Our Ref: JH/I0605/jj

28 October, 2019

**RE: PROPOSED RESIDENTIAL AGED CARE DEVELOPMENT,
56 QUARRY ROAD, BOSSLEY PARK**

COMPLIANCE CHECK
AS2890.1-2004 &
AS2890.2-2018

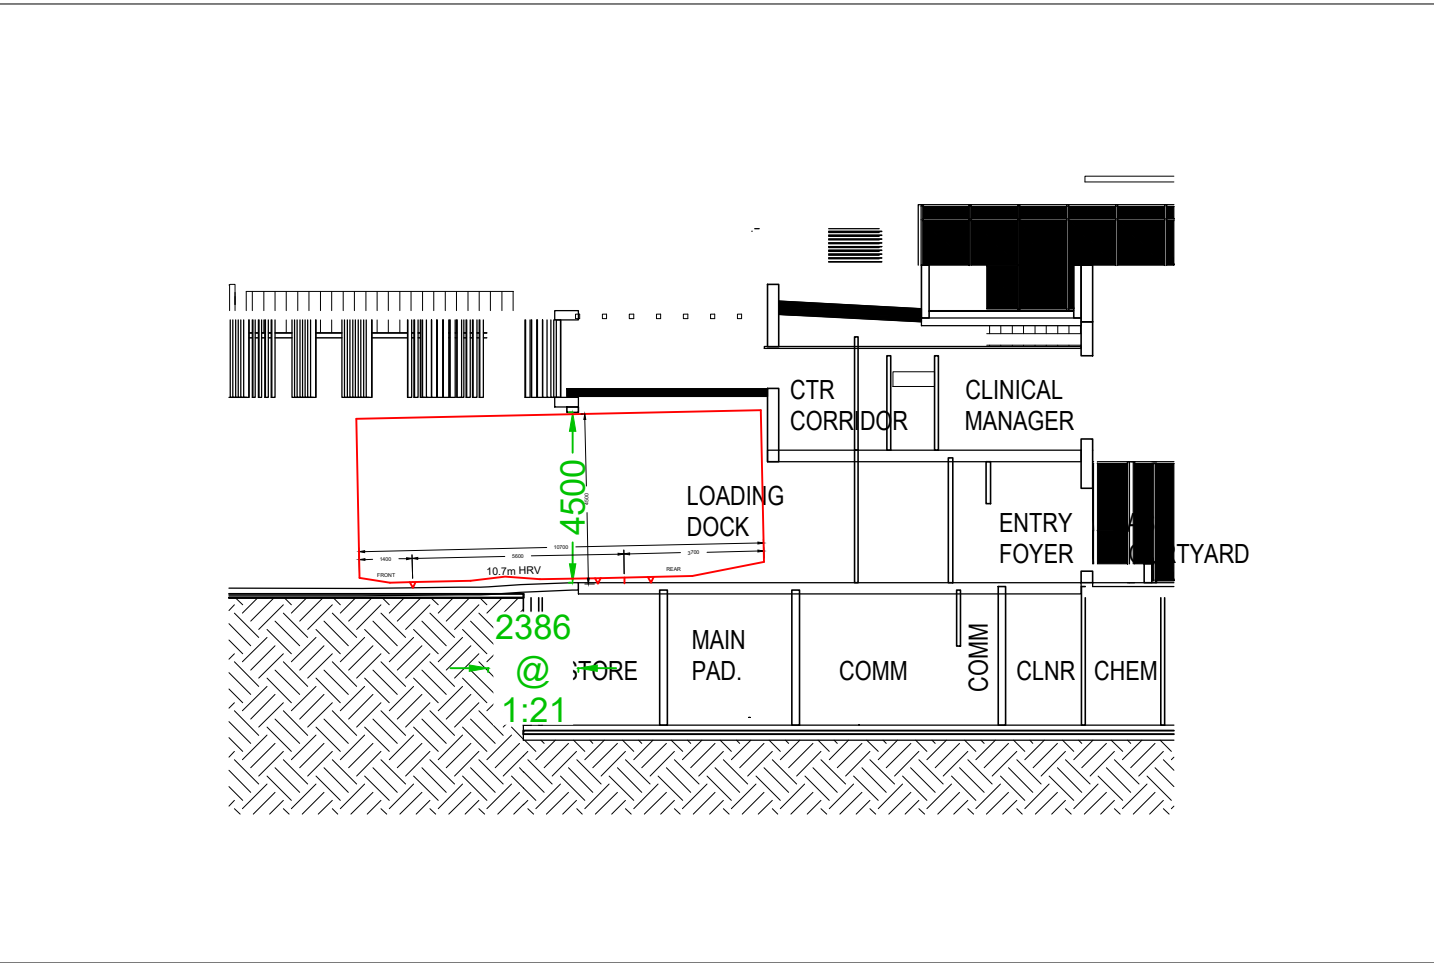
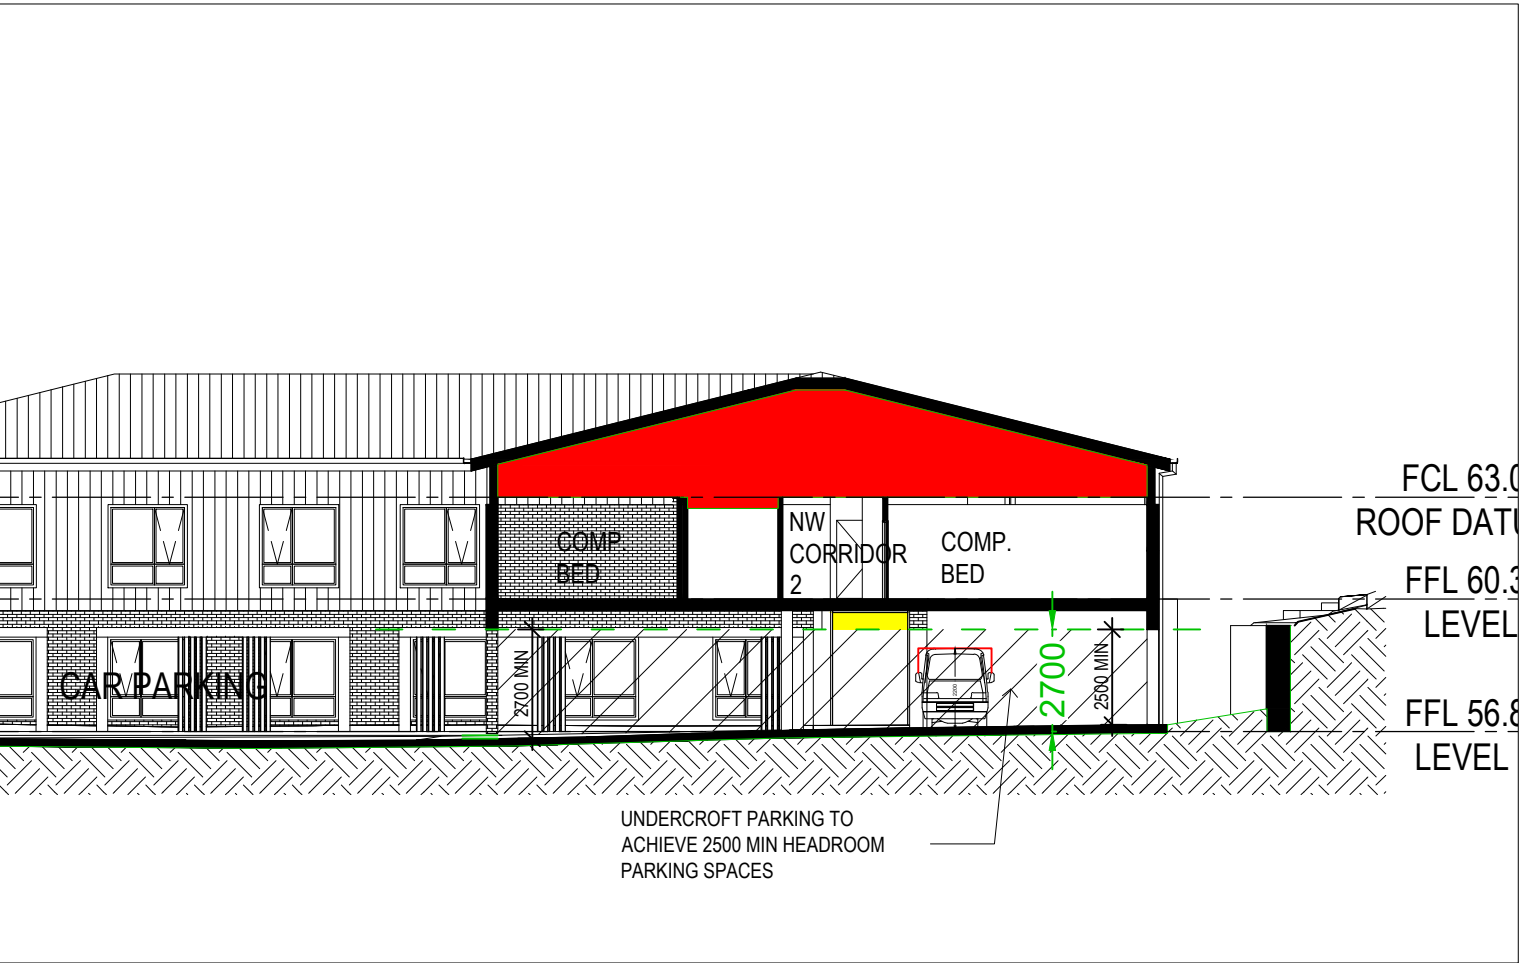
- *The driveway of Quarry Road shall be designed with a minimum width of 6.0m at the property boundary.*
3. The driveway is some 6.3 metres wide at the property line as shown in the attached Figure 1.
 - *The loading bay provided does not appear to be sized in accordance with the dimensions of the service vehicle specified within AS2890.2. The service vehicle appears to obstruct the ambulance space while parking within the loading bay. In this regard, the loading bay shall be designed and dimensioned to fully contain the*

- *Column spacing requirements are set out in AS2890.1.5.2: Column location and spacing. In this regard, column location and spacing is to comply and shall be shown on the architectural plans. The proposed column near space 21 does not comply with Figure 5.2 of AS 2890 Part 1 Off-street car parking. The applicant shall amend the drawing to comply with these requirements.*

6. There is a small area of the car park, at the western end of the development, over which part of the building extends. The columns in this area are shown on the architect's amended drawings are located in accordance with AS 2890.1:2004, as shown in Figure 1.

COMPLIANCE CHECK
AS2890.1-2004 &
AS2890.2-2018

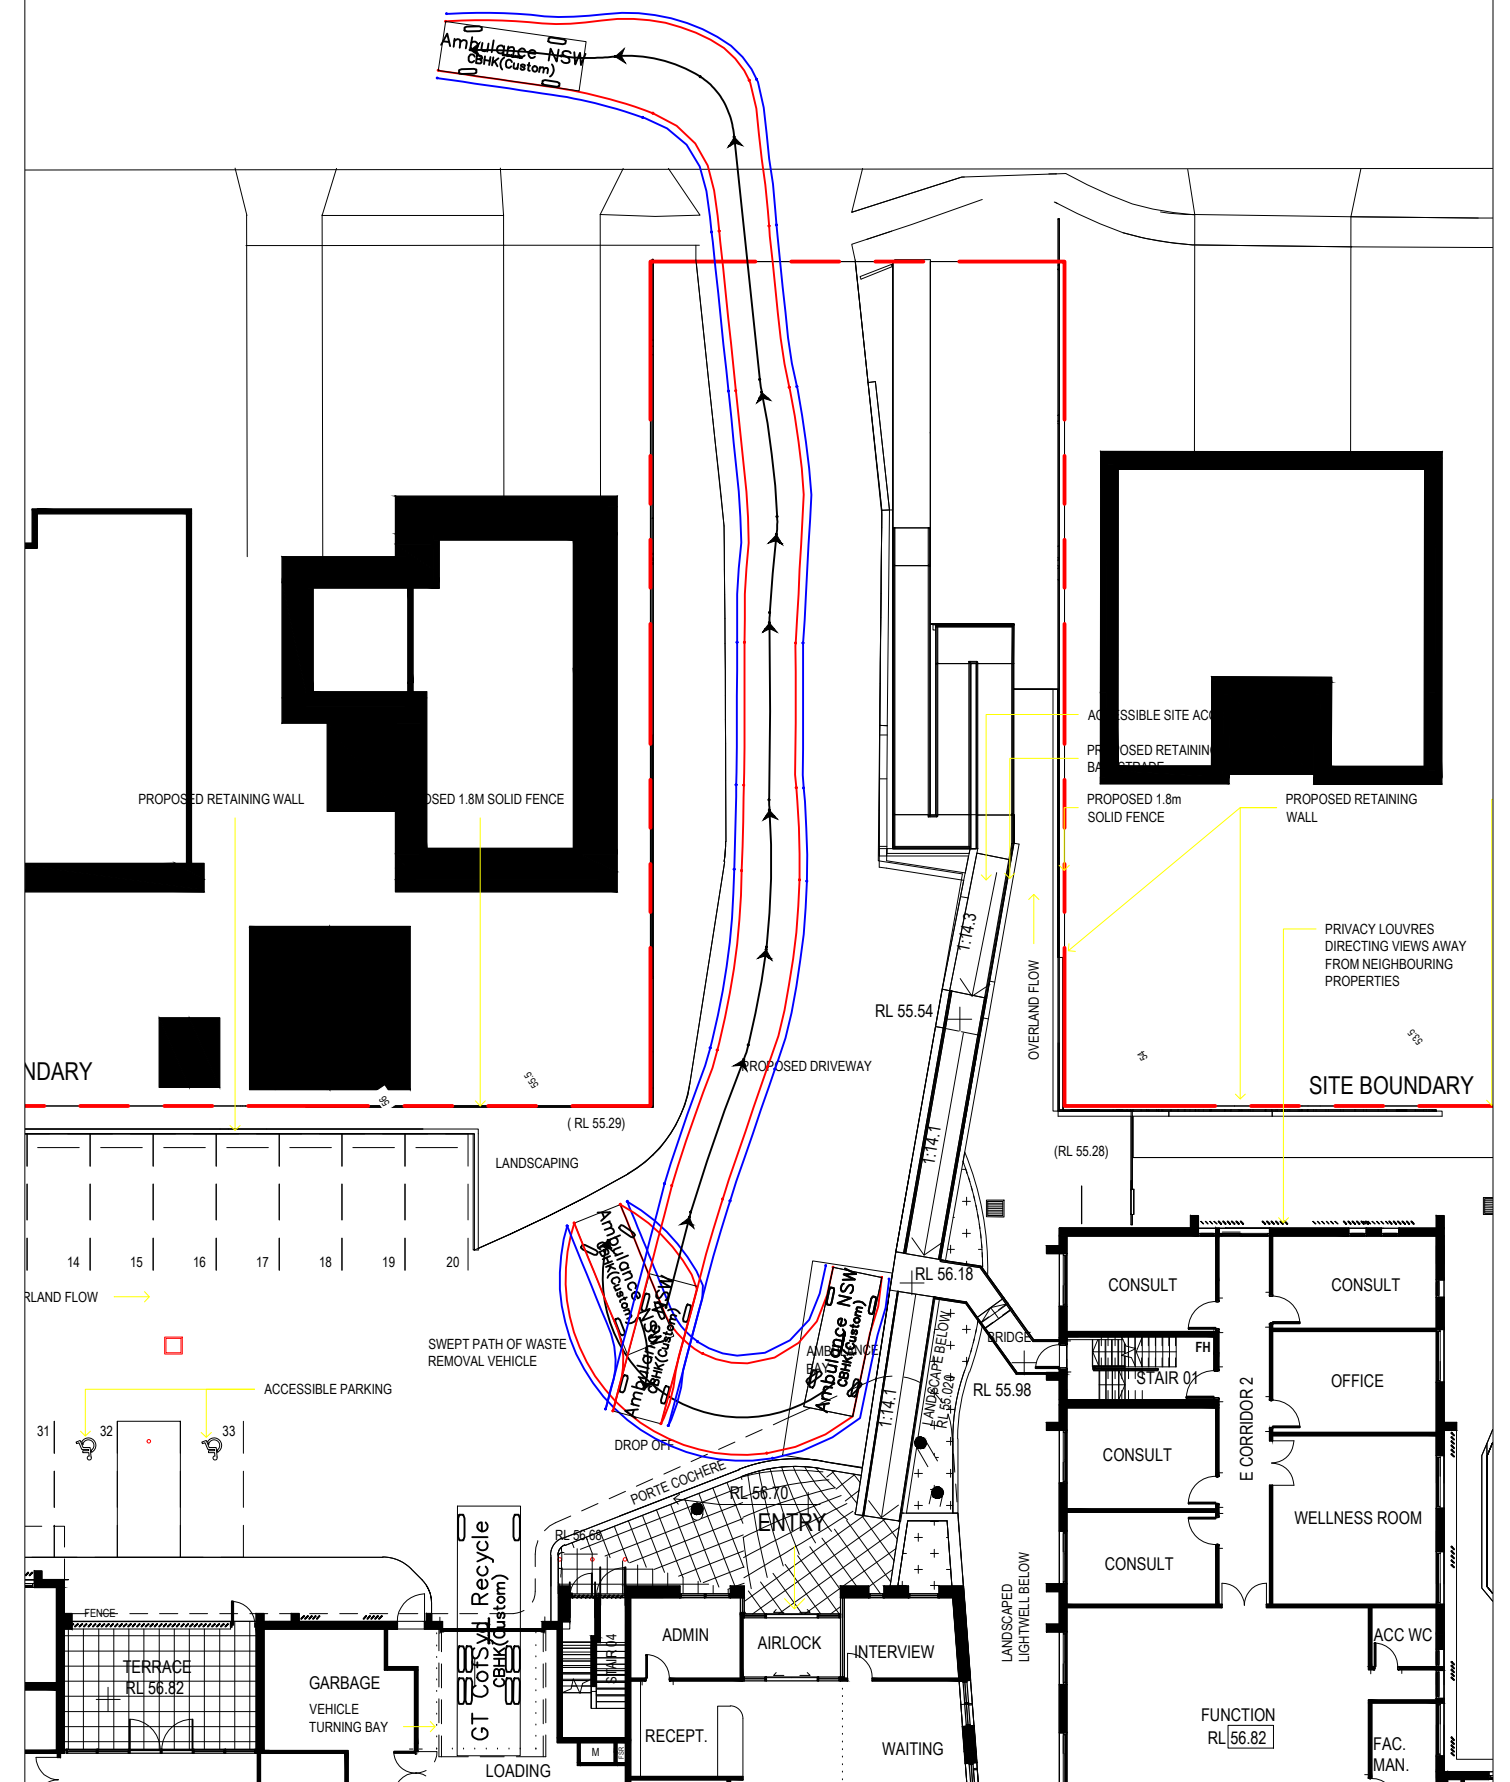
- *No information is provided in regard to the height clearance for the parking spaces on the western side of the property. Amended plans shall include this information.*

11. This matter is addressed above in paragraph 9.
- The height clearance for the proposed loading dock has not been demonstrated on the submitted plans.*

9. The architect's amended plans include this information. A minimum of 2.2 metres height clearance will be provided in this area, in accordance with AS 2890.1:2004 and as shown in Figure 2.

12. The height clearance in the loading dock is 4.5 metres, as shown in Figure 2, which is in accordance with AS2890.2:2018 for medium rigid and larger trucks.

5.62m AMBULANCE SWEEP PATHS

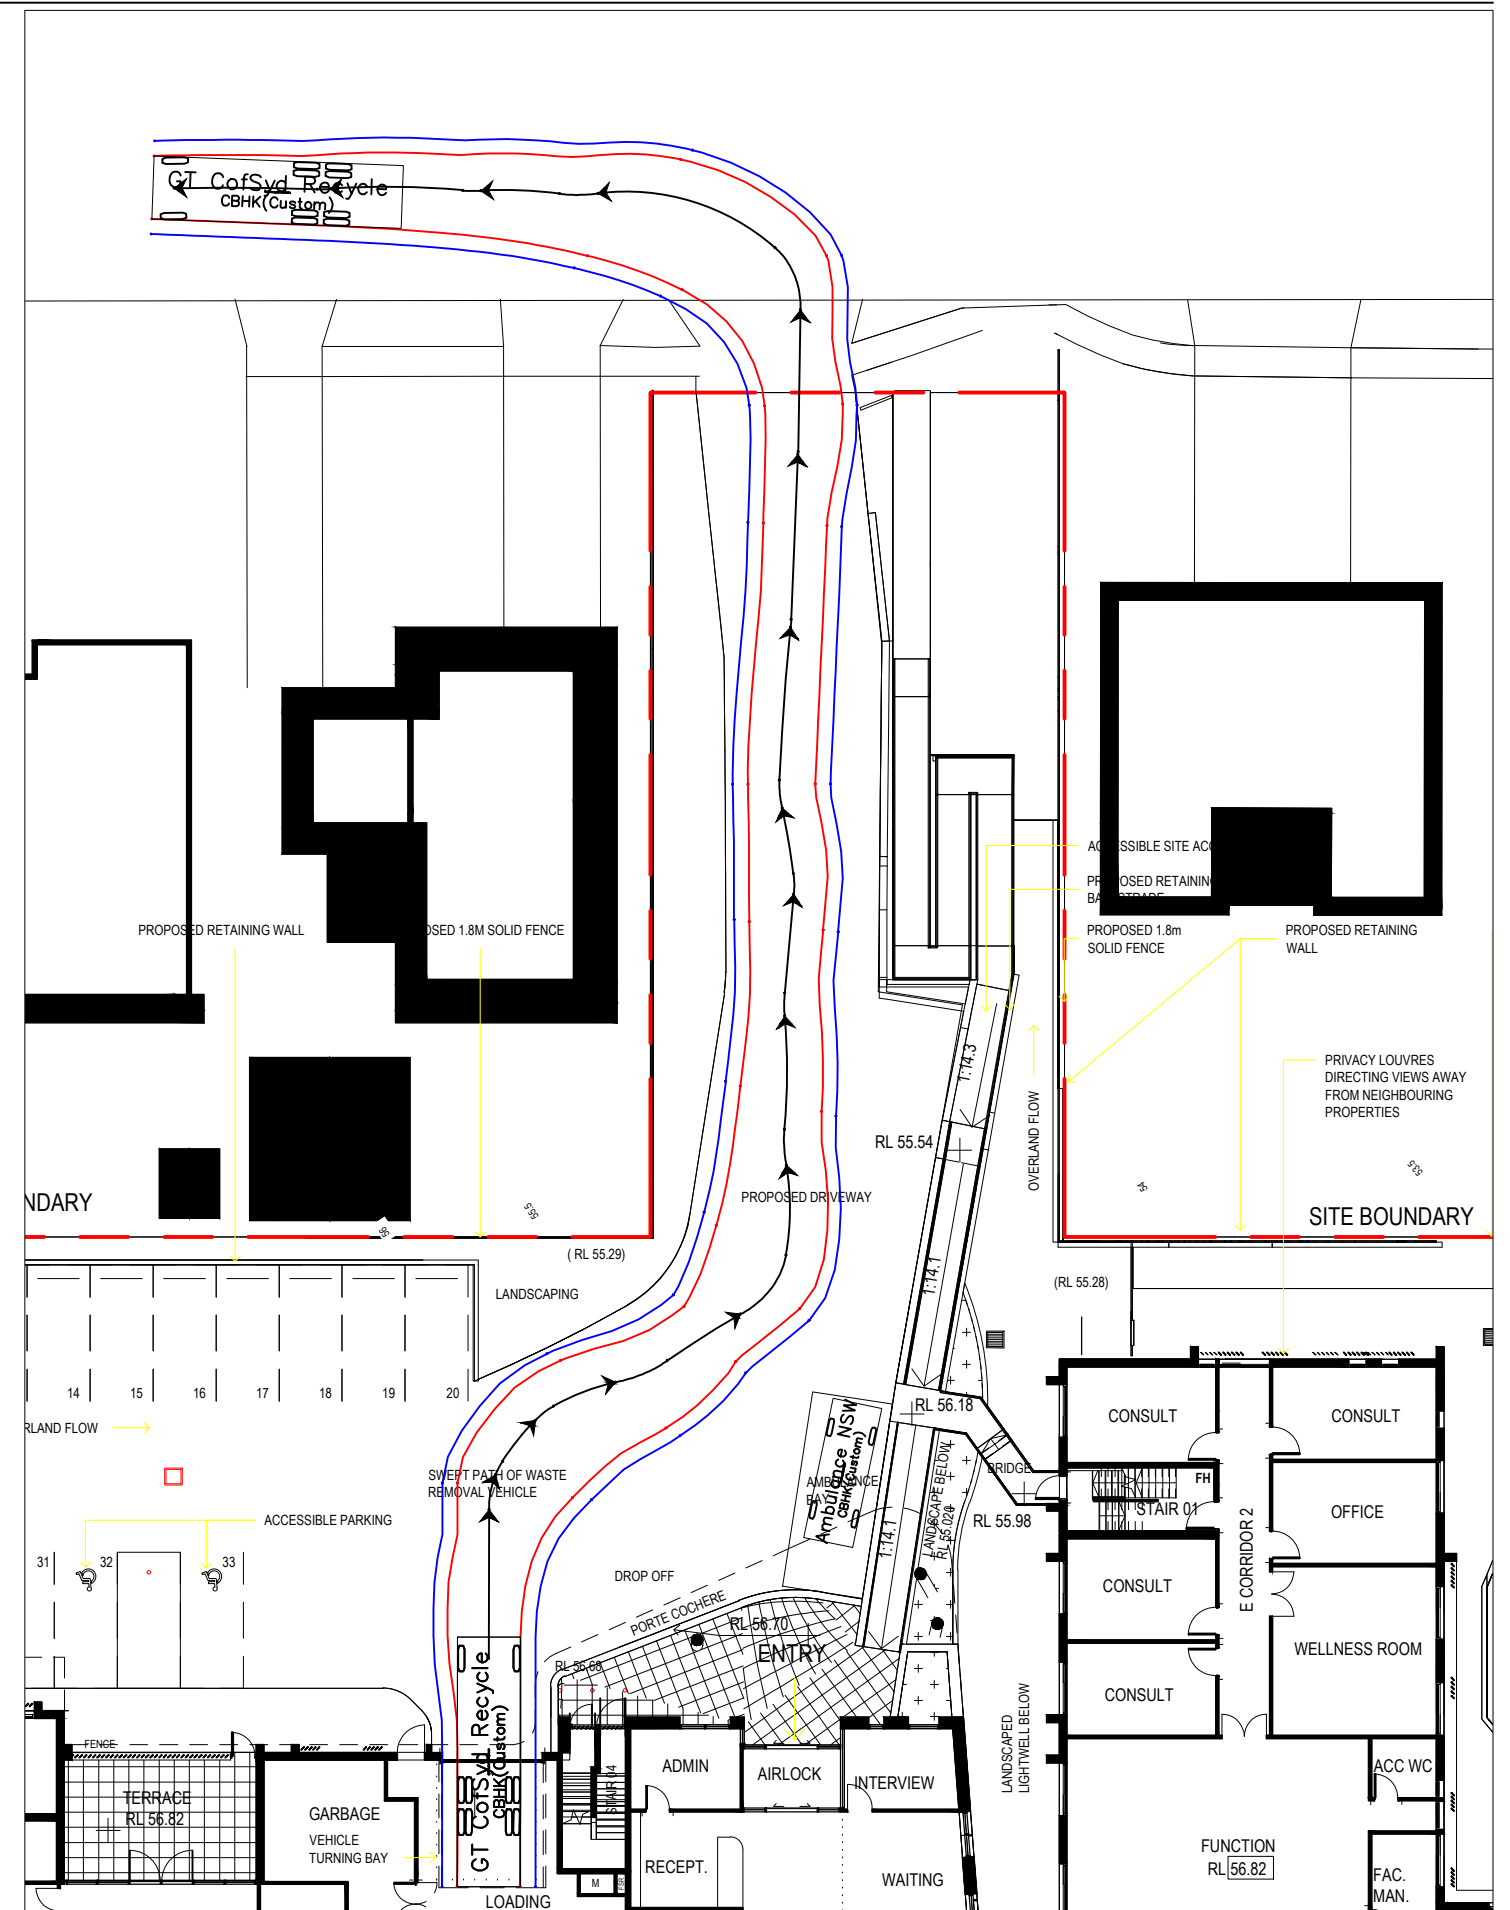
- *Dimensions for the ambulance space are smaller than the requirements of 2890.6. For a parallel parking space a minimum of 3.2m wide and 7.8m long space is to be provided. In this regard, the parking space is to be redesigned meeting the minimum requirements of AS2890.6. Further information regarding the standard ambulance dimensions can be found from www.ambulance.nsw.gov.au.*

- *Swept path diagrams have not been provided for an ambulance entering, maneuvering, and exiting in a forward direction.*
8. This matter is addressed in paragraphs 5 and 7.

5. However, swept paths are attached to this letter as Figure 3 showing that an ambulance will be able to enter and exit the bay with a truck in the loading dock.

7. The above dimensions from AS 2890.6:2009 are for a disabled parking space, not an ambulance bay. As noted above, an ambulance will be able to enter and exit the bay, as shown in Figure 3.
